THE ABBEY
PLANNED UNIT DEVELOPMENT
No. 06-013

A memo from the
CITY of SAN ANTONIO
Development Services
Master Development

SUBJECT: PUD# 06-013

Name: The Abbey, PUD

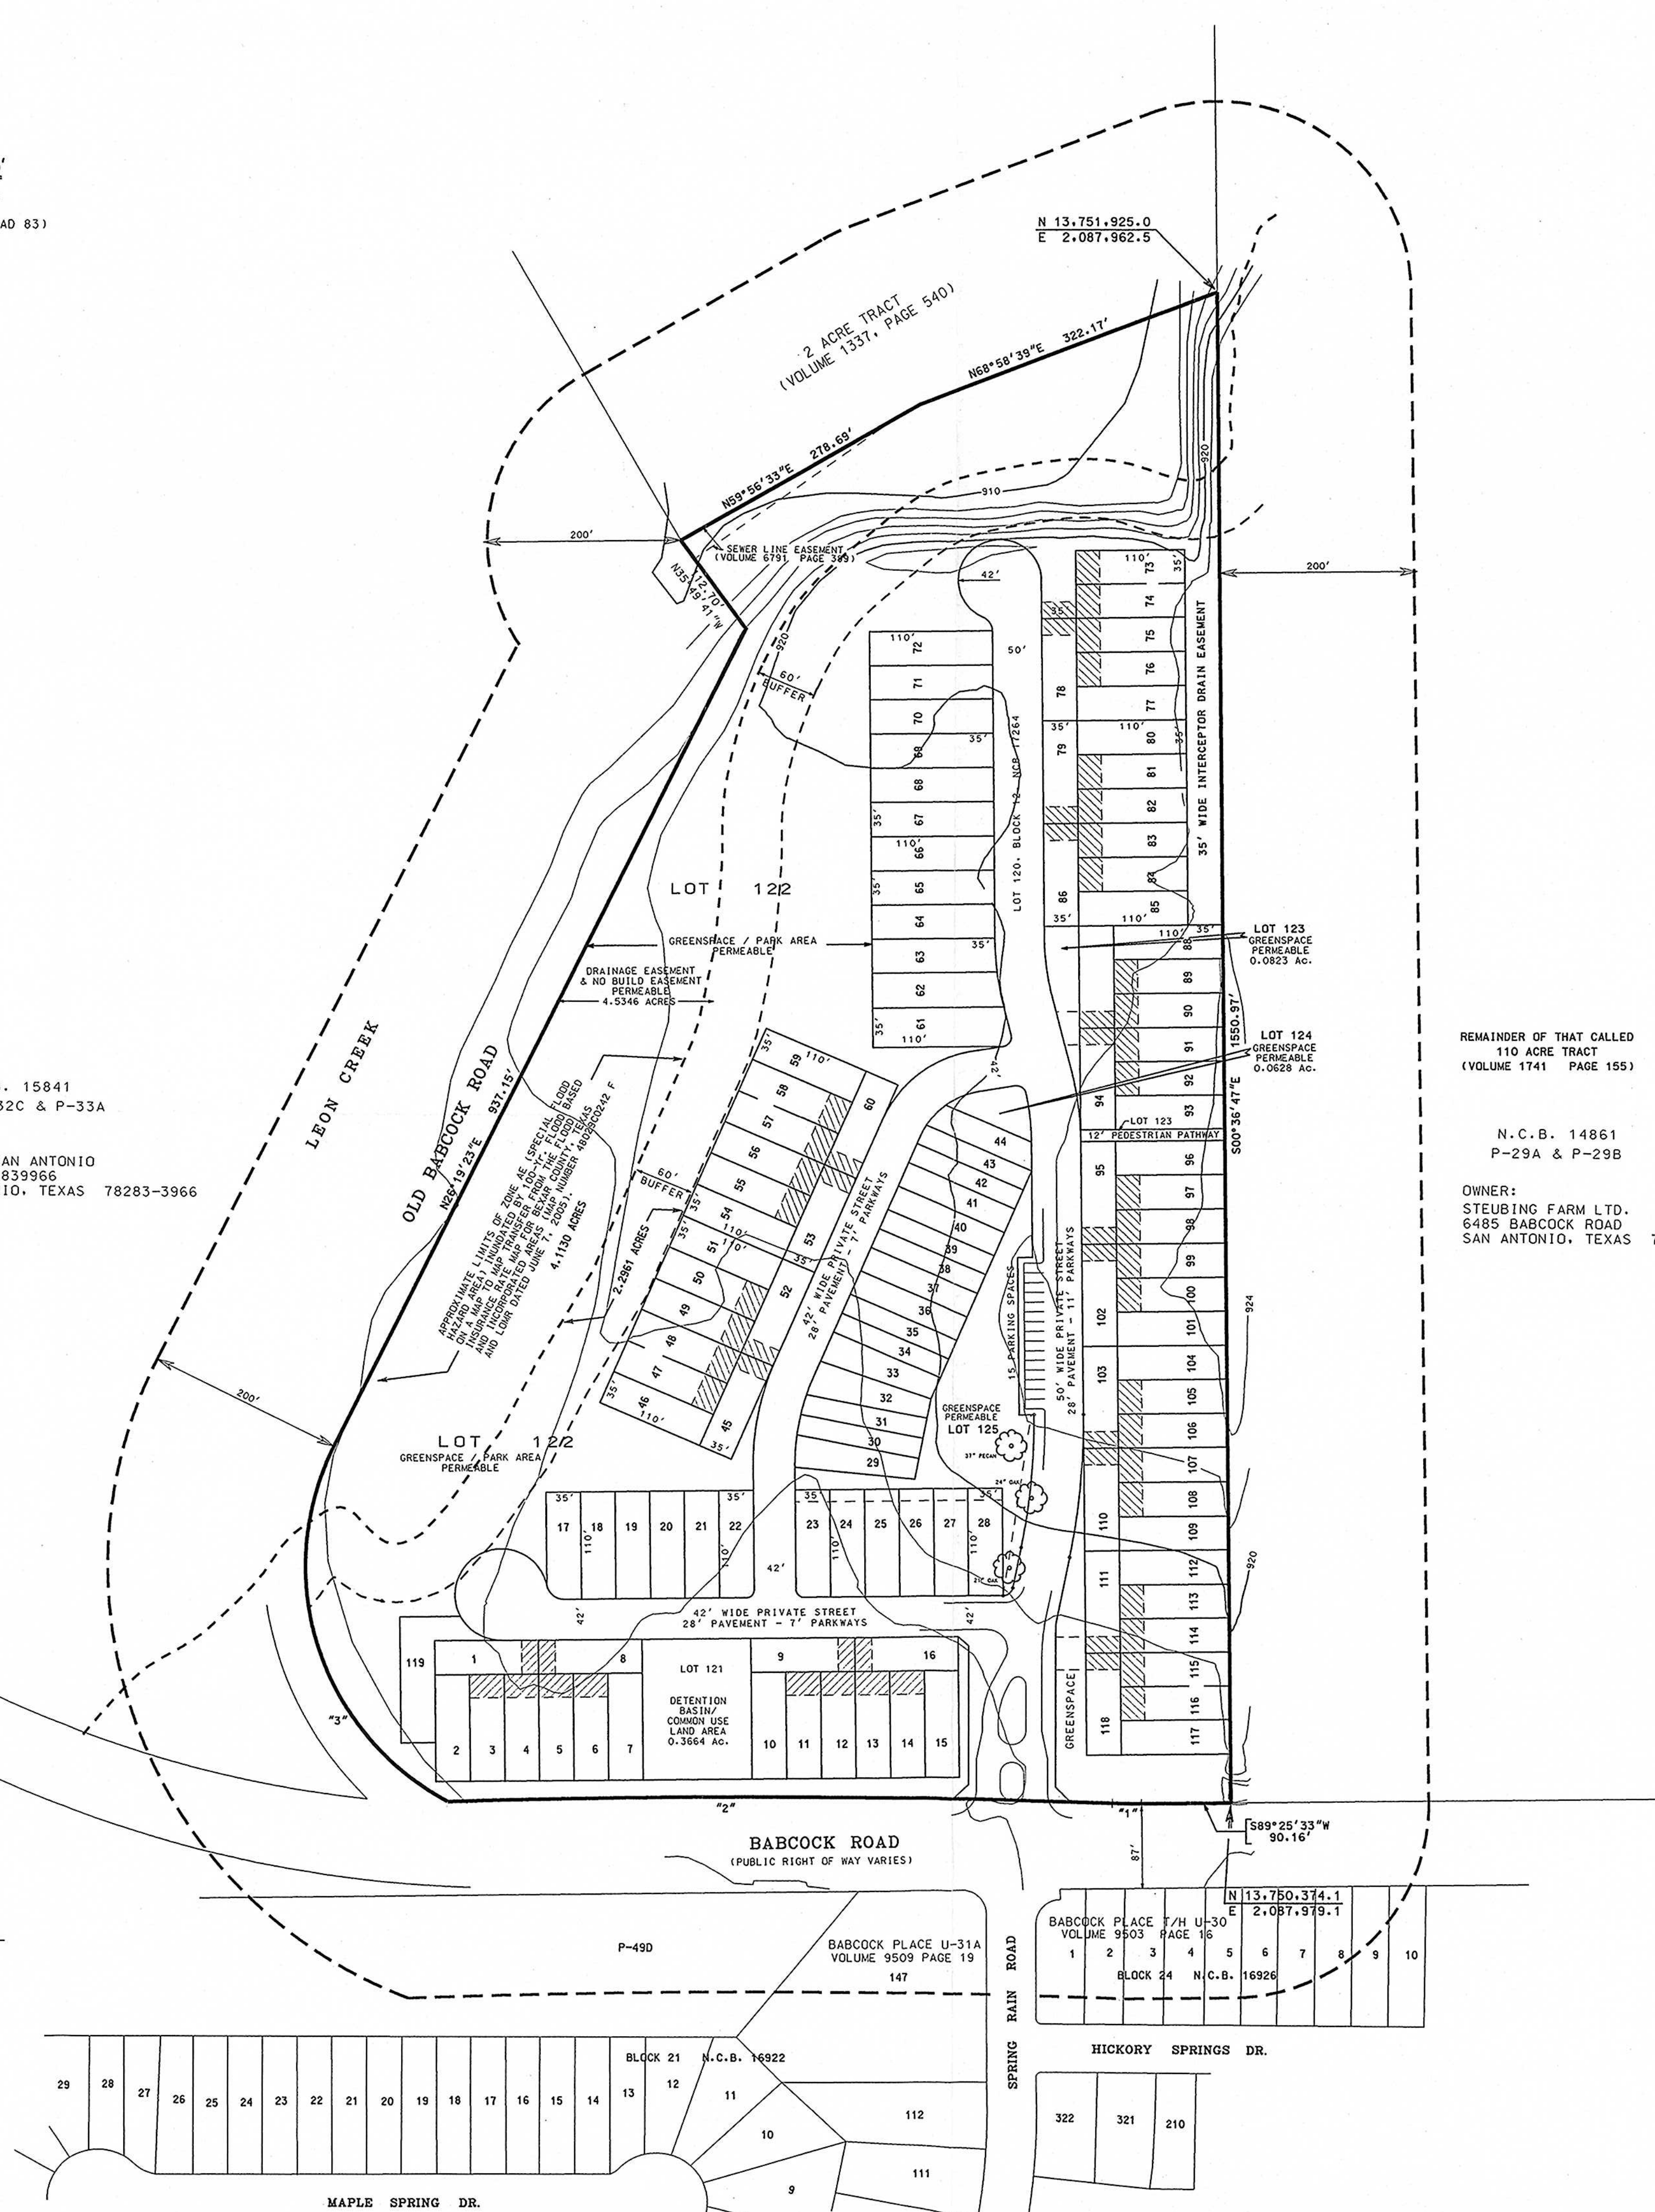
- The dedicatory instrument(s) (Legal Instrument) for common areas and facilities must be approved by the City Attorney as to legal form prior to any plat recordation and shall be recorded at the same time as the plat. UDC 35-344(i)
- **DSD – Traffic Impact Analysis & Streets** The PUD Plan shall comply with the following:

1. UDC 35-502 (A) (9) Roadways
2. UDC 35-506 (Q) Sidewalks
3. All access shall provide clear sight distance.

- **SAWS Aquifer Protection and Evaluation** will require the following pursuant to the Aquifer Protection Ordinance No. 81491, for Plat Certification.

1. 100 year Flood Plain Shown and Buffering (if applicable)
2. Significant Recharge Features and Buffering (if applicable)
3. Category Letter for All Site Specific Plats (if Category 2 or 3, an Aquifer Protection Plan is required) (if applicable)

Additionally a Water Pollution Abatement Plan or Contributing Zone Plan must be submitted to and approved by the Texas Commission on Environmental Quality (TCEQ) prior to construction.

According to the Water Quality Ordinance # 81491, Section 34-913, buffering may be required.

- The Texas Sites Atlas indicates that archaeological sites have been previously identified within/nearby the above referenced property. Also, the property may contain other sites, some of which may be significant. The project area is adjacent to Leon Creek, a drainage that is known to contain significant archaeological sites including prehistoric burial sites. Thus, before any work that might affect any sites is begun, we recommend that qualified professionals conduct an archaeological and historical structures investigation of the property.

1. The parkland is dedicated to the Home Owners Association
2. A Provision and Maintenance Plan is provided to this department at the time of platting.
